Re: Highlands Market Parking Lot
1111 Central Aven. NE
Traffic Circulation Layout
Engineer's/Architect's Stamp 01-07-2020 (K15D034D)

Based upon the information provided in your submittal received 01-07-2020, the above referenced plan cannot be approved for Building Permit until the following comments are addressed:

SITE PLAN

A10.01
SHEET NUMBER

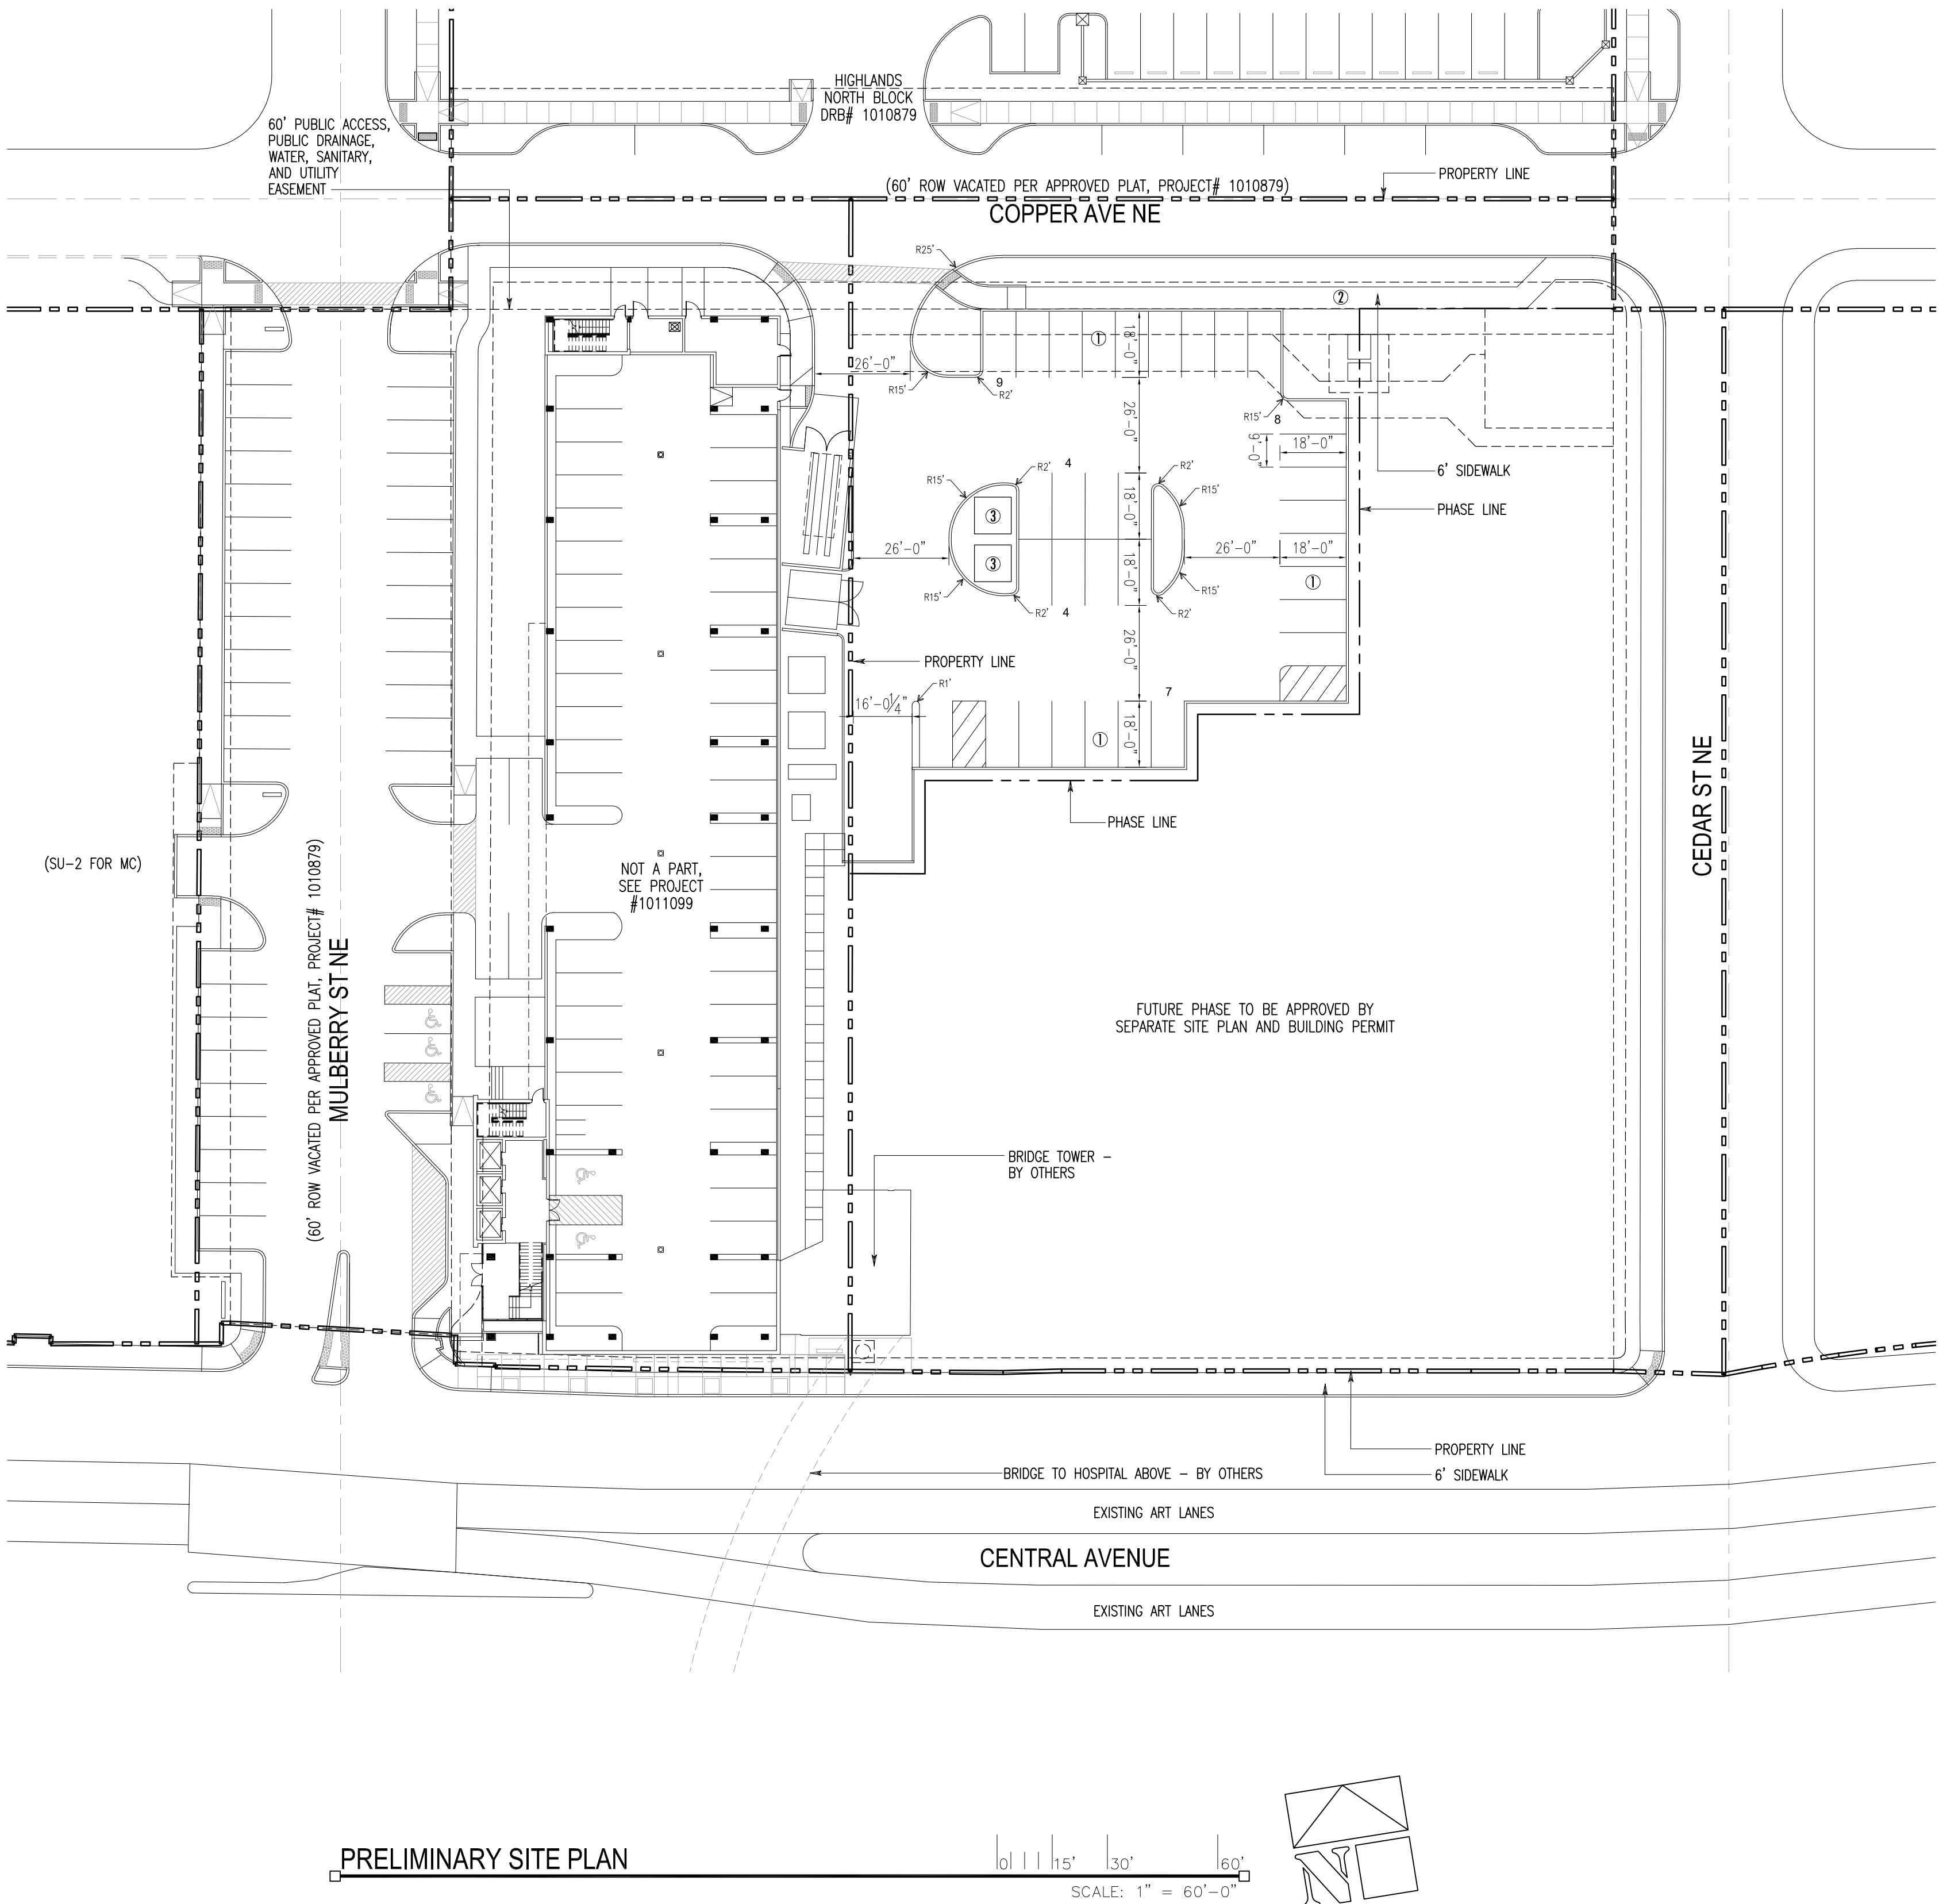
1. The parking table shows 35 spaces, but there are 32 spaces on site.
2. Where is the ADA space?
3. ADA curb ramps must be updated to current standards and have truncated domes installed.

4. Where is the motorcycle parking?
5. Where is the bicycle parking?
6. Per the IDO, a 6 ft. wide ADA accessible pedestrian pathway is required from the public sidewalk to the building entrances. Please clearly show this pathway and provide details.

7. It is not apparent what type of pavement surface is being proposed. A hard driving surface will be required as part of this proposed project for parking area and drive aisles.

8. Show the clear sight triangle and add the following note to the plan:
"Landscaping and signage will not interfere with clear sight requirements. Therefore, signs, walls, trees, and shrubbery between 3 and 8 feet tall (as measured from the gutter pan) will not be acceptable in the clear sight triangle.

9. Shared Site access: driveways that straddle property lines, or are entirely on one property but are to be used by another property, shall have an access easement. Please include a copy of your shared access agreement with the adjacent property owner.

10. Provide notes showing what work is included and on the work order and the private work on site.
11. Please add a note on the plan stating "All improvements located in the Right of Way must be included on the work order."

12. Unused curb cuts must be replaced with sidewalk and curb & gutter. A build note must be provided referring to the appropriate City Standard drawing.
13. Add a note stating "All broken or cracked sidewalk must be replaced with sidewalk and curb & gutter." A build note must be provided referring to the appropriate City Standard drawing.
